St. Johns Church Hall
Hallowell Road
Northwood

PLANNING APPLICATION

INTERNAL ALTERATIONS
PROPOSED GROUND FLOOR

Drawn By	LL	Date	Dec 2023
Checked By	JS	Date	04.12.24
Approved By	JS	Scale	100 / 50 @A1
Drawing No.		Rev.	
5530-PL-103			B

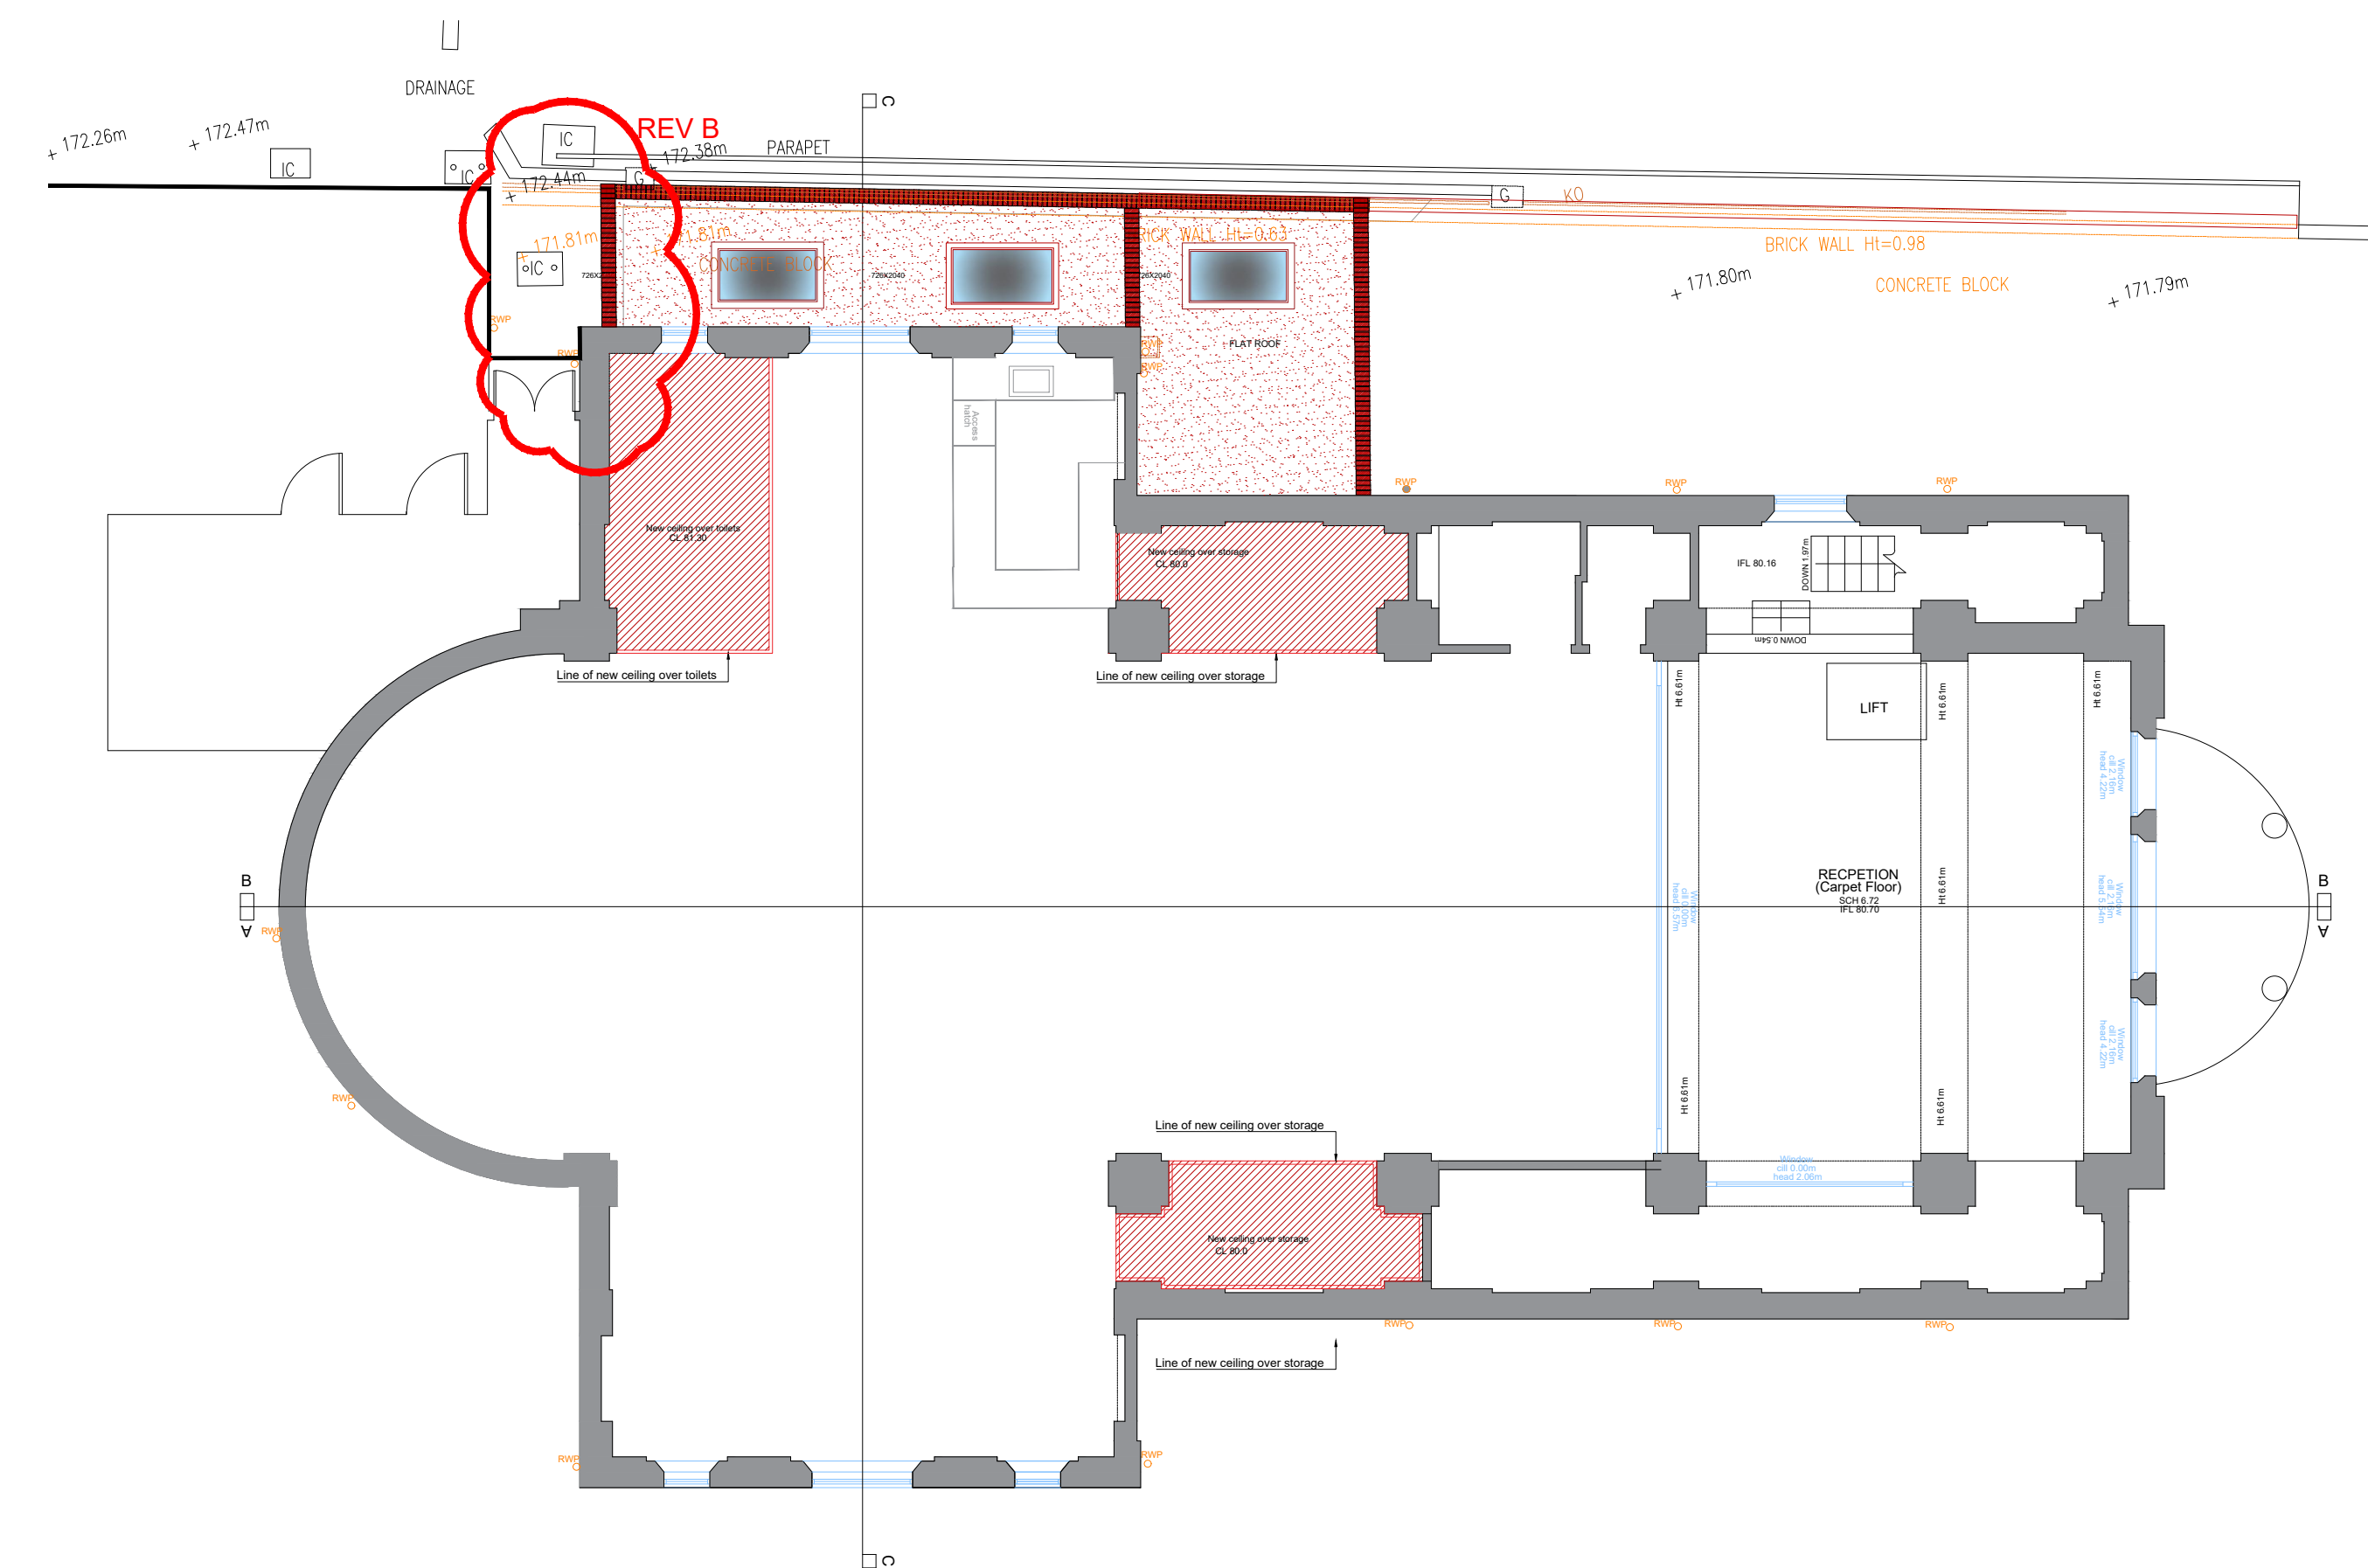
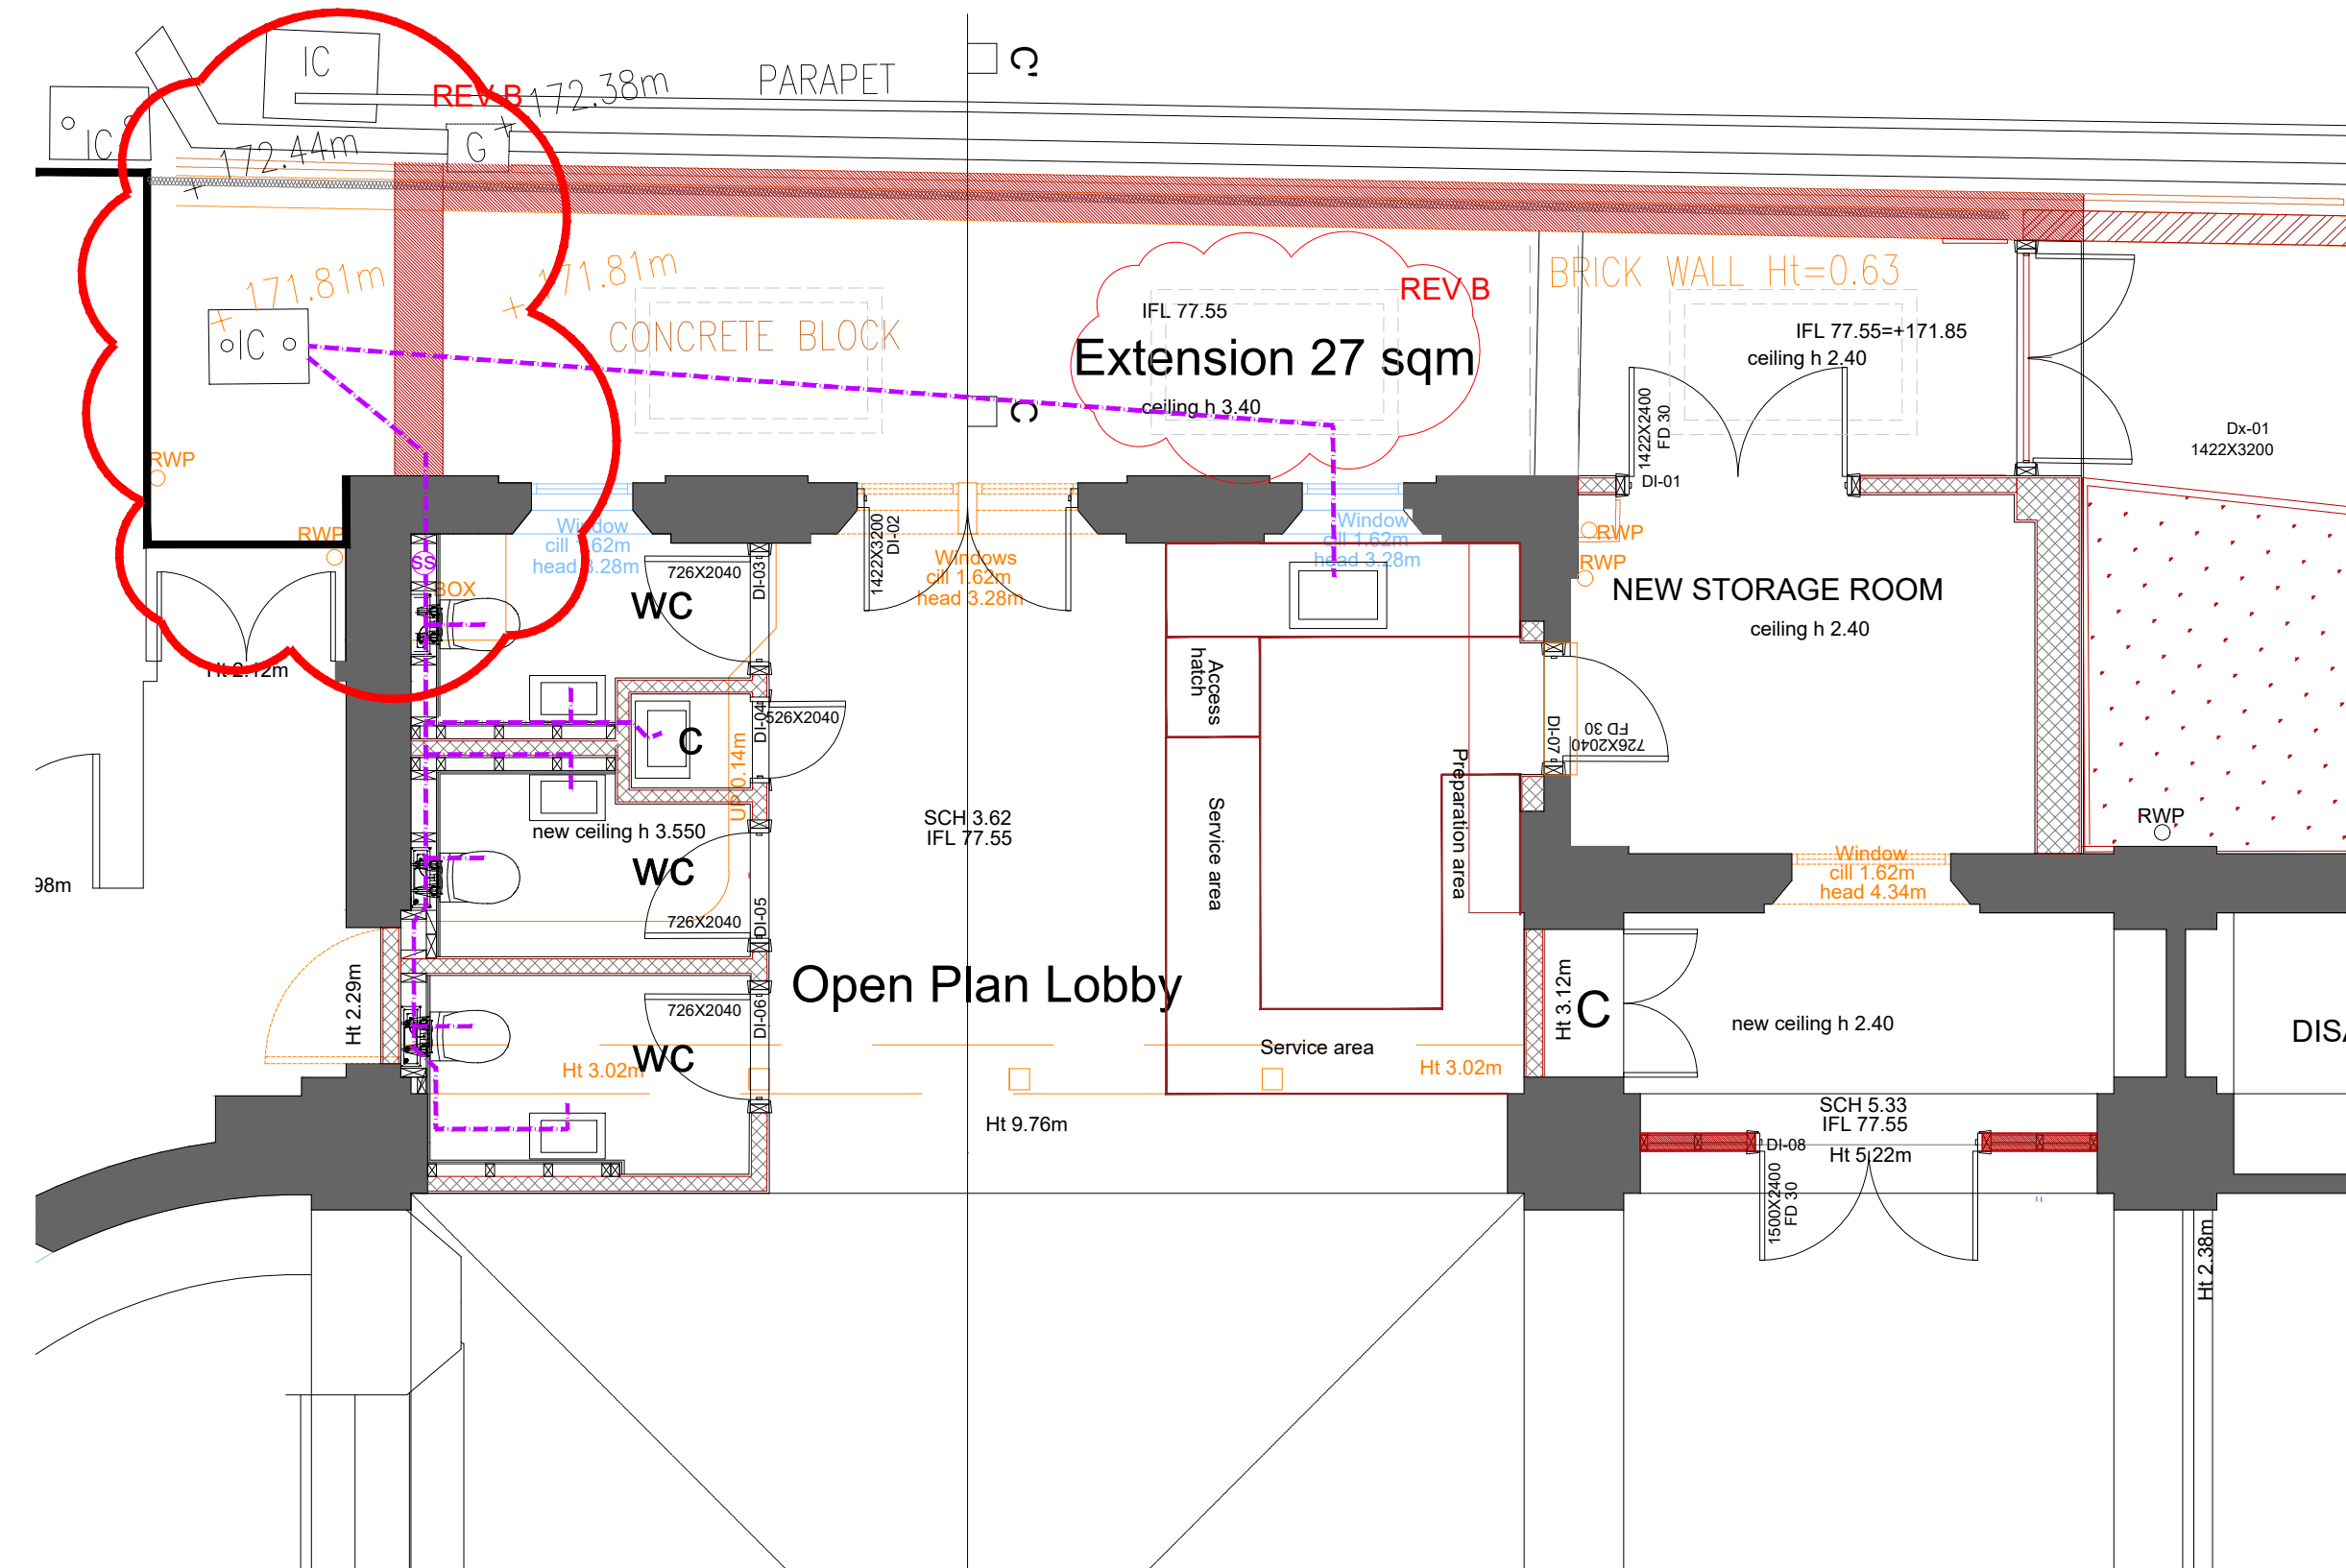
Amendments/Notes			
Rev.	Detail	By	Date
A	Planner's comments 14.08.24 Reduce length and roof height on the front part of the extension .	LL	15.08.2024
B	Section 73-variation of condition #2 Due to Thames Water constraints Reduced the extension length, added a door at the opposite end, and left the existing public manhole near the rear building outside the new extension.	LL	04.12.2024
